No.	Date	Revision/Issue
	12/08/08	DSA SUBMITTAL
	02/11/09	DSA SUBMITTAL
	5/11/09	DSA BACKCHECK
1A	12/16/2011	ADDENDUM 1A
1B	01/20/2012	ADDENDUM 1

MUIR
FUNDAMENTAL
SCHOOL MODERNIZATION
1951 MABURY ST.
SANTA ANA, CA 92707

BUILDINGS 6 & 7
POWER PLANS

E3.4

BUILDING 7 - POWER PLAN 1/8"=1'-0" 2

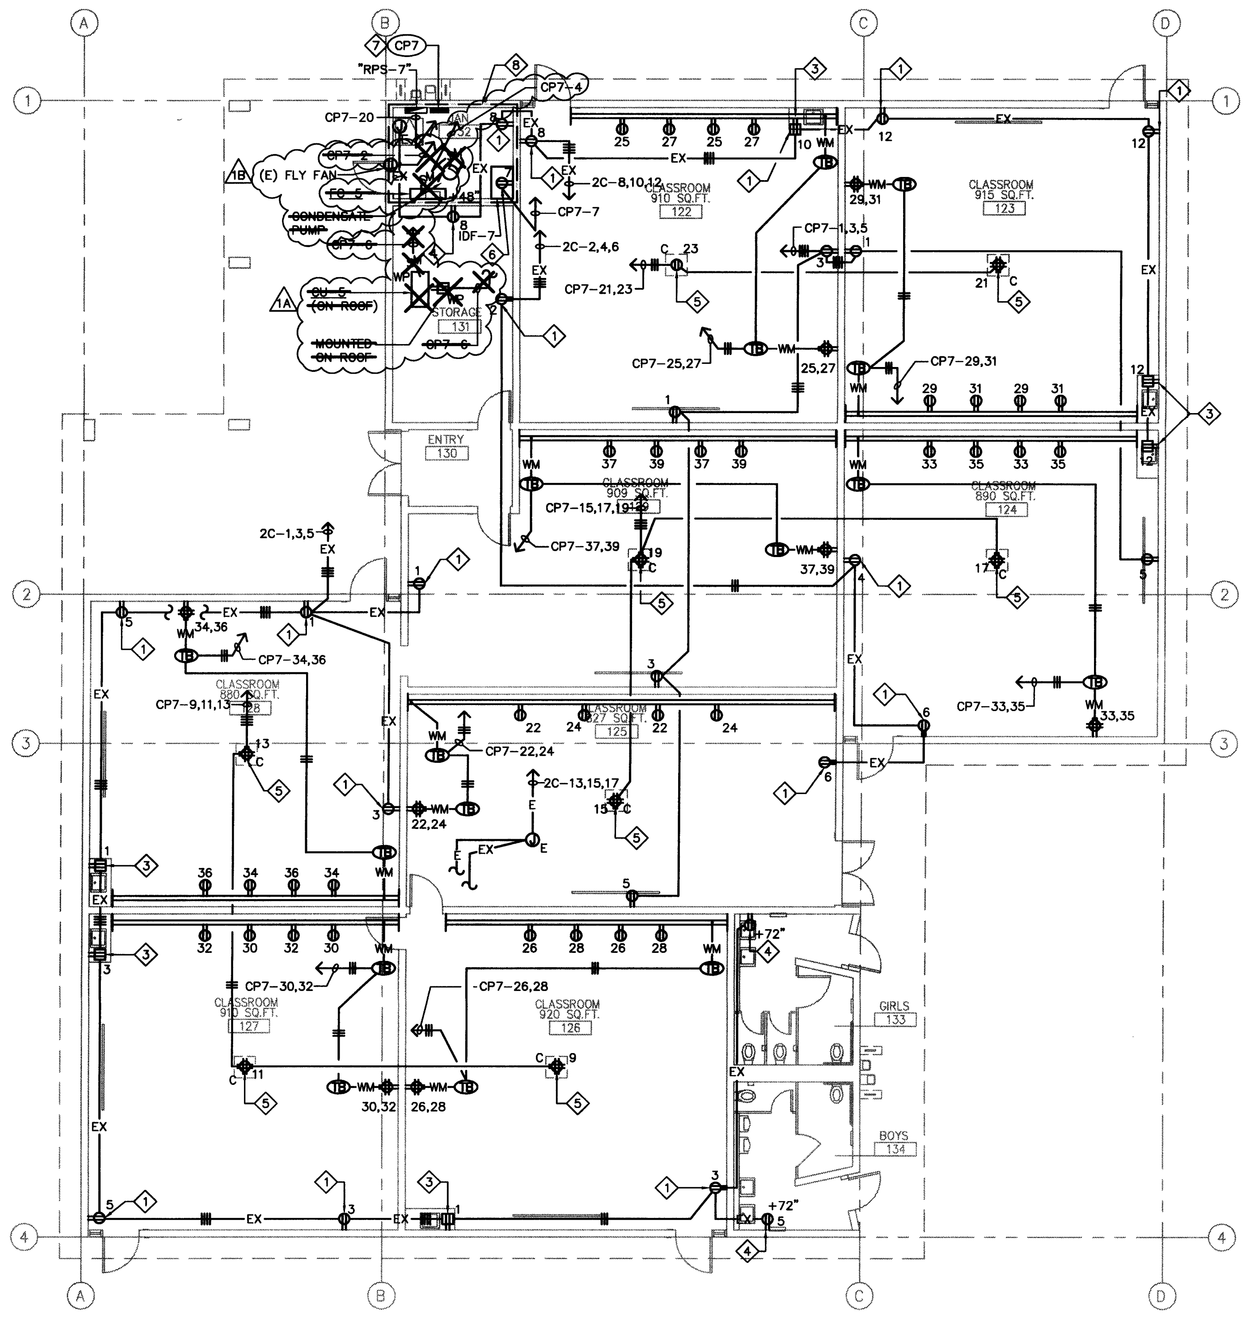
1. ~~REPLACE AND ADJUST MOUNTING HEIGHT OF NON-ADA COMPLIANT DUPLEX RECEPTACLE AND JUNCTION BOX. EXTEND EXISTING CONDUIT TO THE NEW MOUNTING HEIGHT OF DUPLEX RECEPTACLE. MOUNTING HEIGHT OF NEW DUPLEX RECEPTACLE SHALL BE +16" AFF MINIMUM TO BOTTOM LINE OF DUPLEX RECEPTACLE.~~ NIC

BUILDING 6 - POWER PLAN 1/8"=1'-0" 1

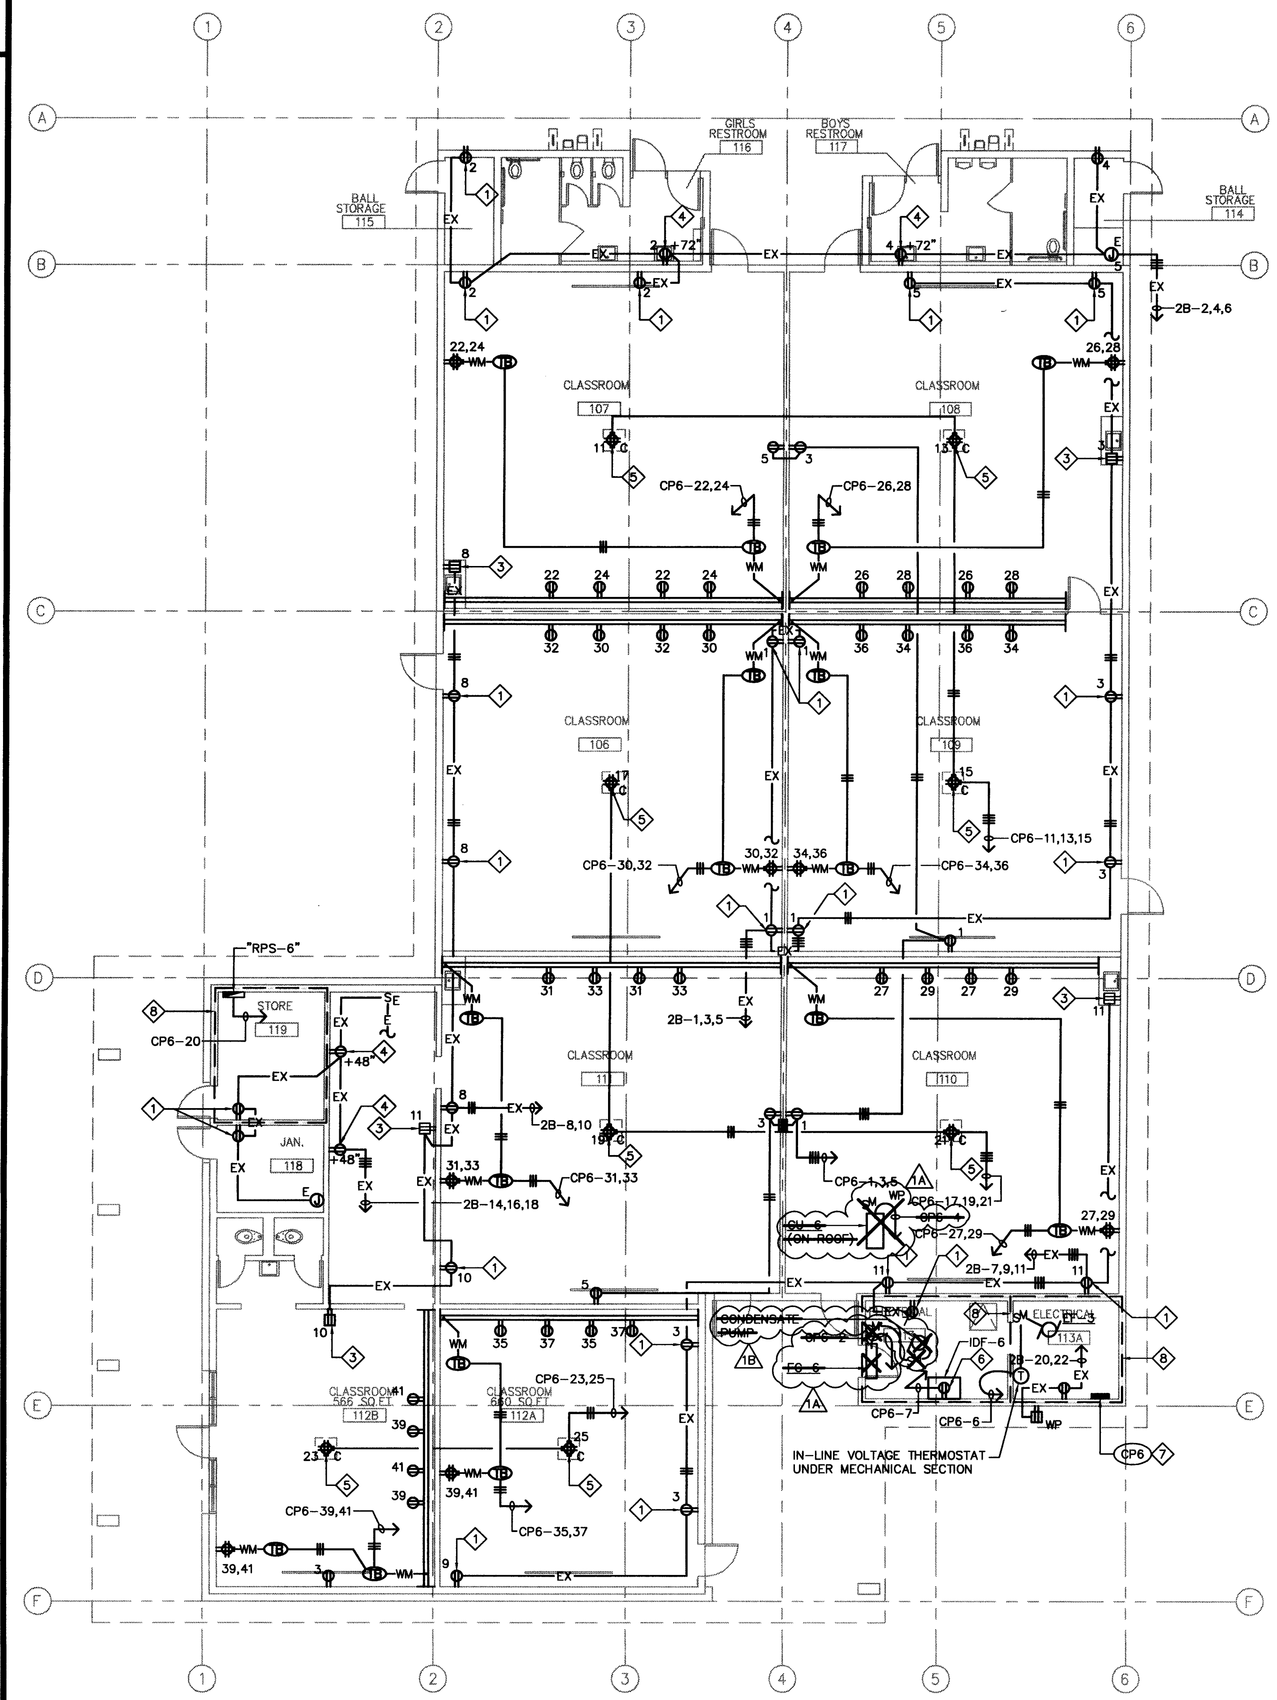
1. ~~REPLACE AND ADJUST MOUNTING HEIGHT OF NON-ADA COMPLIANT DUPLEX RECEPTACLE AND JUNCTION BOX. EXTEND EXISTING CONDUIT TO THE NEW MOUNTING HEIGHT OF DUPLEX RECEPTACLE. MOUNTING HEIGHT OF NEW DUPLEX RECEPTACLE SHALL BE +16" AFF MINIMUM TO BOTTOM LINE OF DUPLEX RECEPTACLE.~~ NIC
